DESIGN REVIEW COMMITTEE RECORD OF ACTION

ITEM NO: 2
Time: 1:35 pm
File No.: DRH21-0003

Subject: Camping Resort, "River Electric"
Applicant: ShelterCo / Kelsey Sheofsky
Staff: Gary Helfrich

Date: April 7, 2021
File: DRH21-0003
Action: RETURN FOR FINAL REVIEW

LIGHTING LEGEND & SPECIFICATIONS

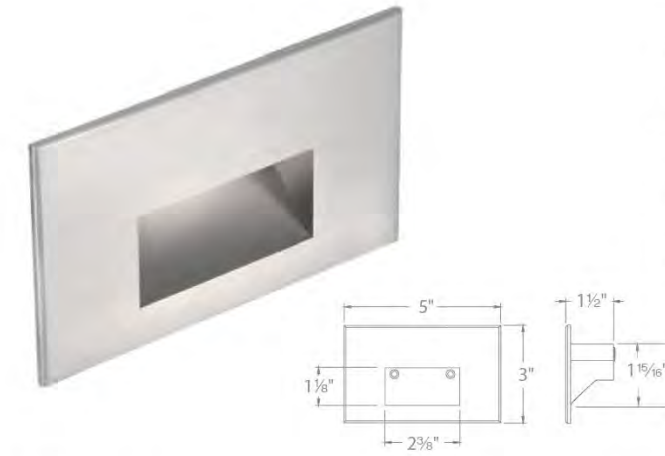
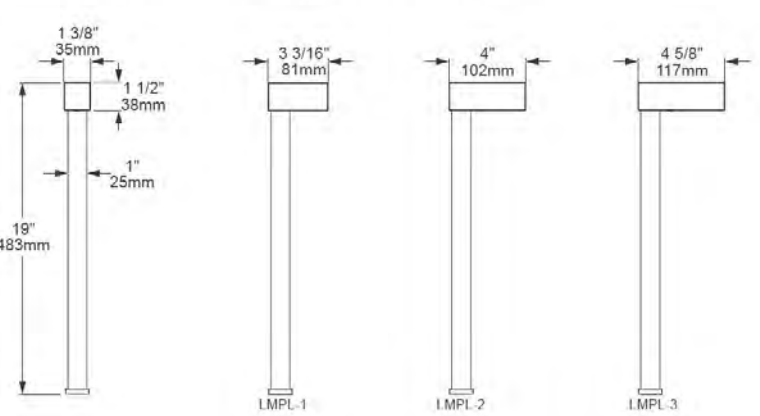
13. Submit final lighting plan and cut sheet details, including for parking and trash enclosure areas

14. Consider use of bollard style fixtures to the extent possible where feasible

Lighting details provided in new plan set.

Lighting details provided in new plan set.

1 ELEVATION: PRIVACY FENCING, TYP.

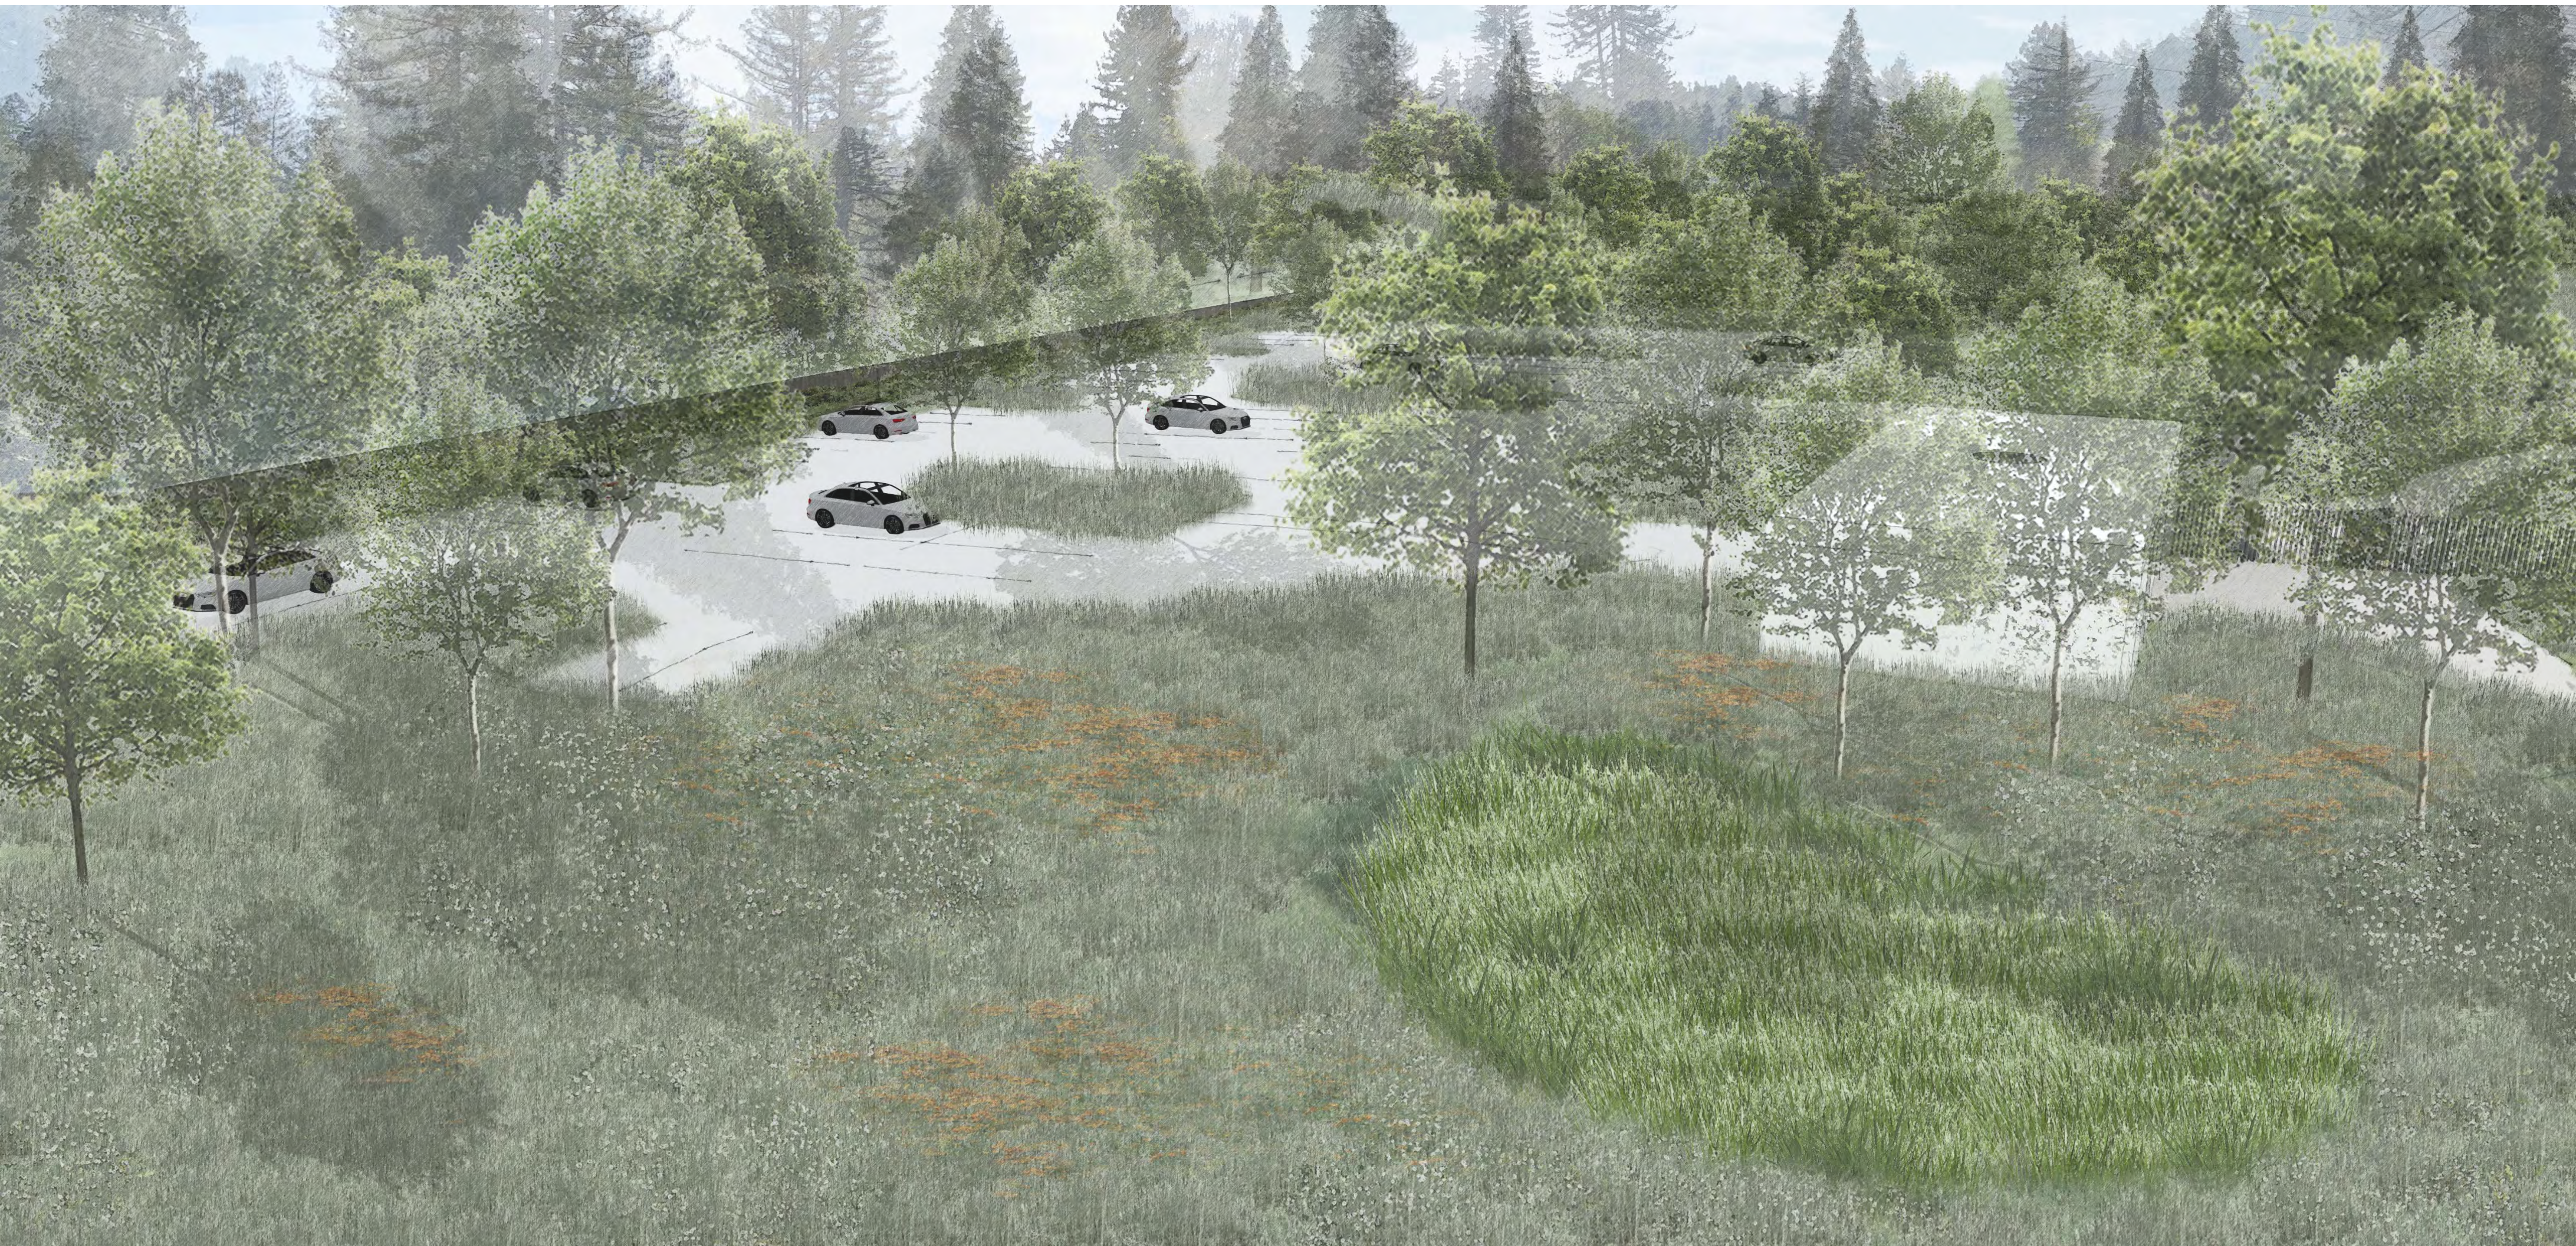
8. Consider appropriate fencing and/or landscape solution for buffering adjacent parcel from parking area and potential headlight spillover.

Rendering provided in new plan set showing 7' opaque wood fence. This plan has been reviewed with the neighboring property owners.

7' HT OPAQUE WOOD SCREEN FENCE -
VERTICAL BOARD-ON-BOARD,
NATURAL FINISH

1 TRASH ENCLOSURE - PROPOSED PLAN
1/4" = 1'-0"

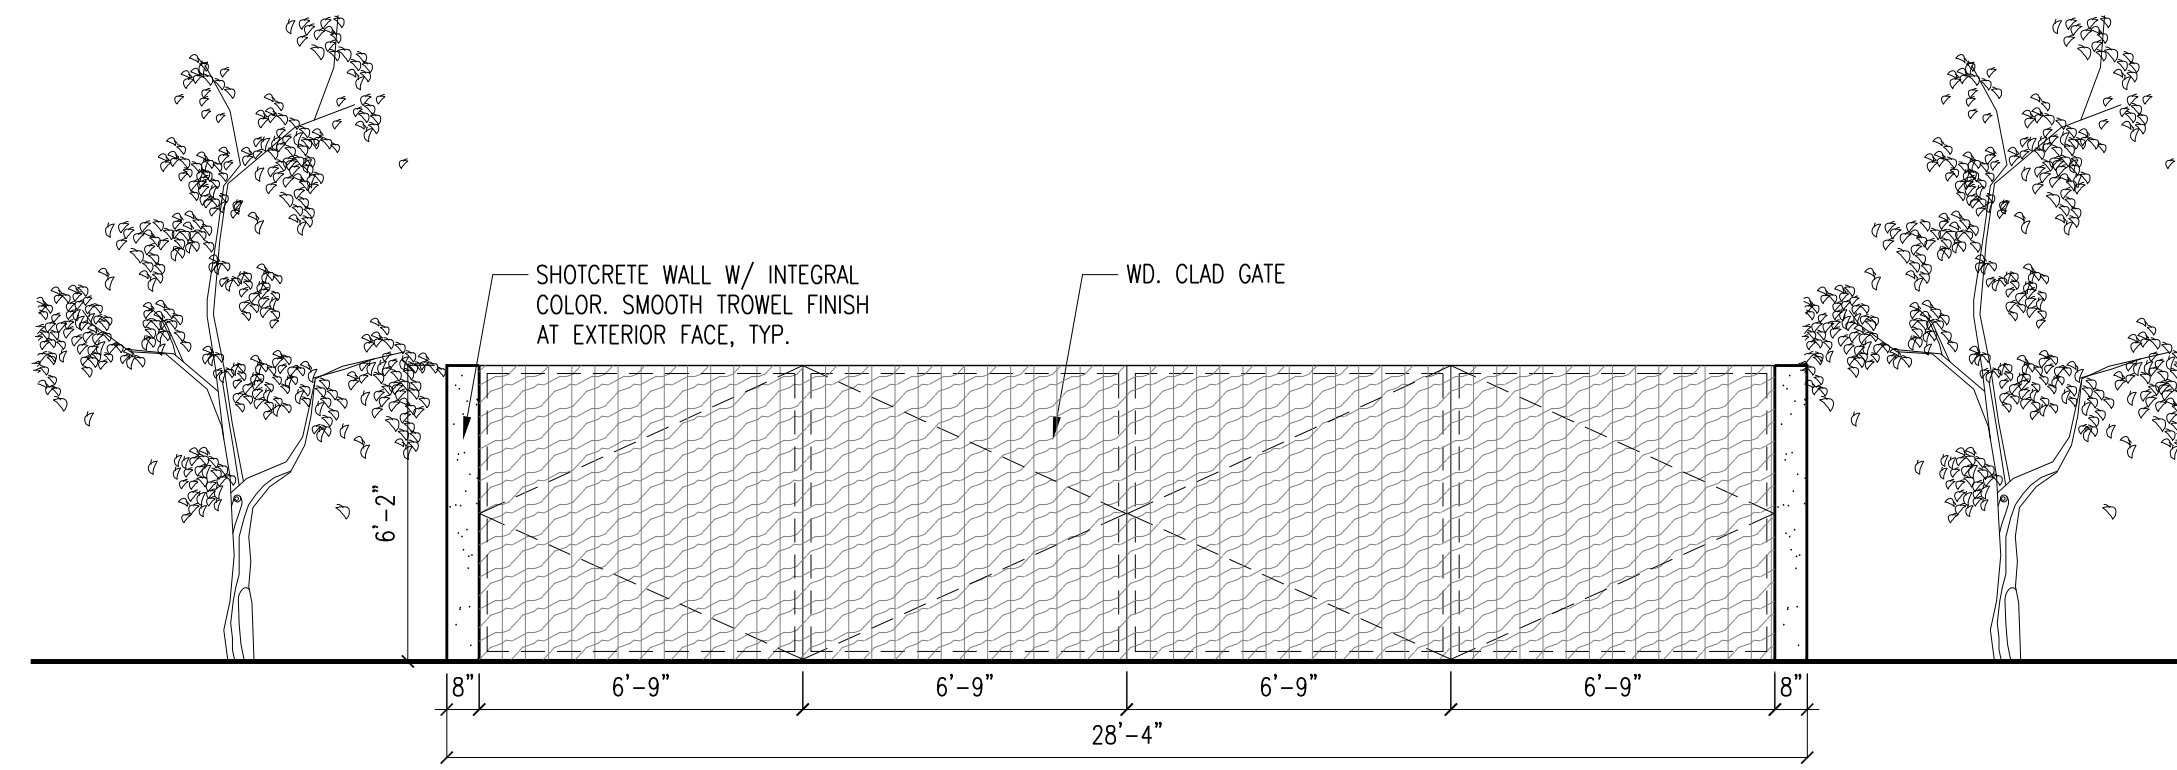
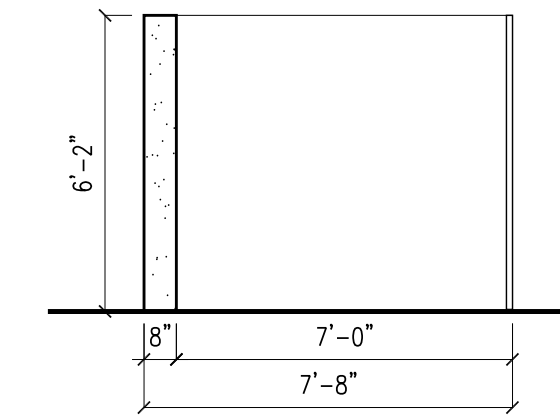
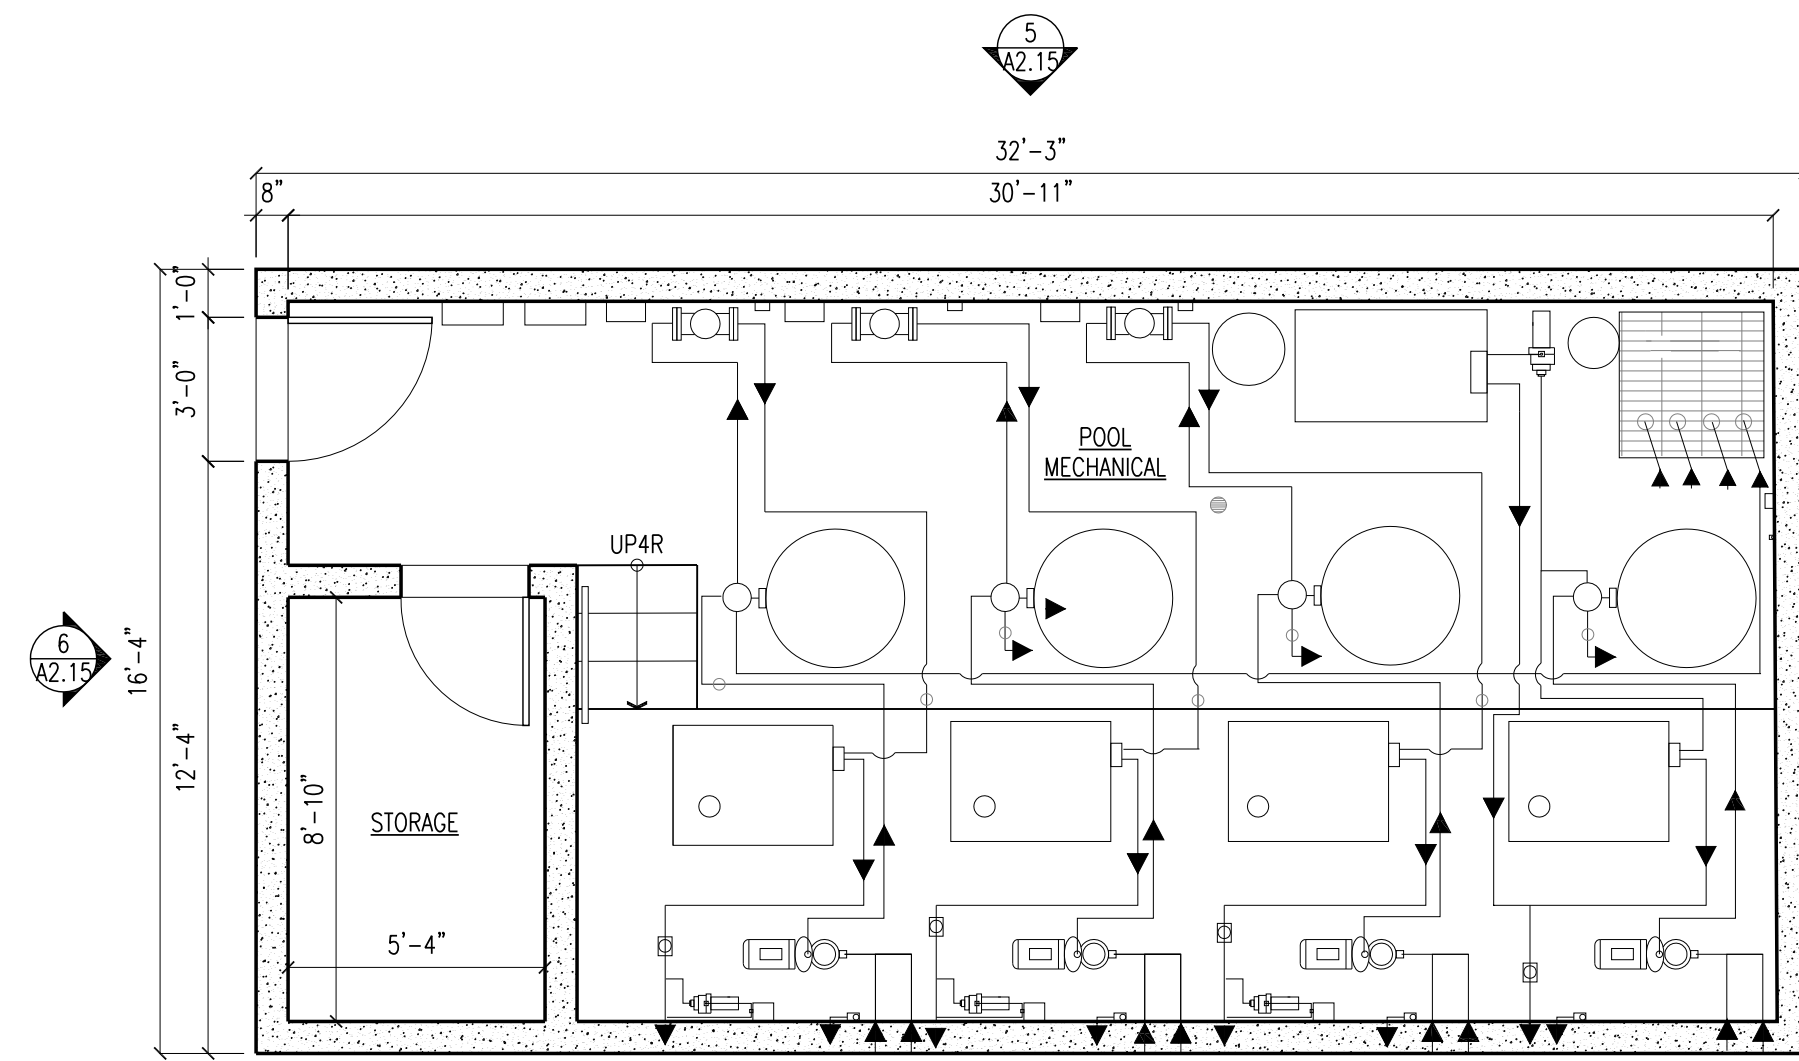
5. Provide exterior elevations for main trash enclosure and individual receptacle concept.

Provided in new plan set. Please see detail on page 11 of the Design Review Set.

5 PROPOSED MATERIAL PALETTE

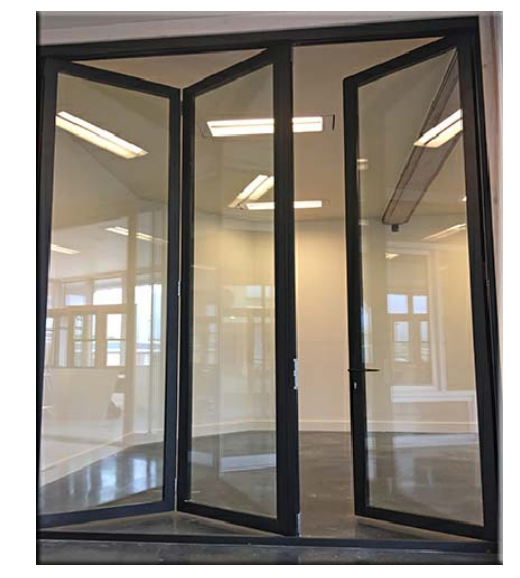
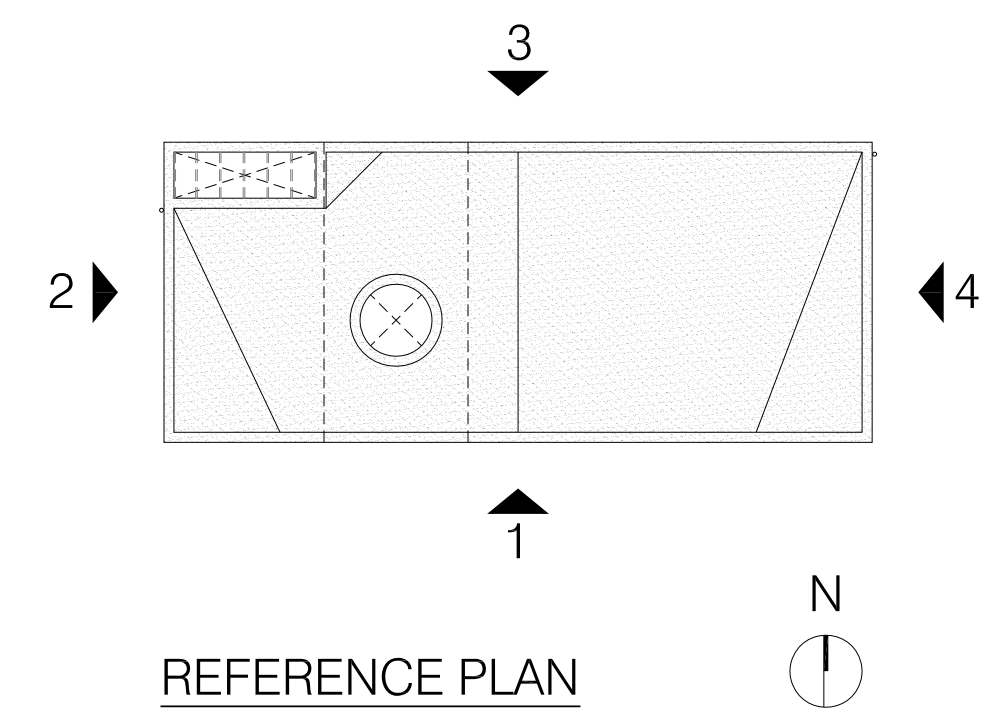
11. Include for final review an colors and materials sheet for all exterior finishes and surfaces

Materials sheet provided in new plan set.
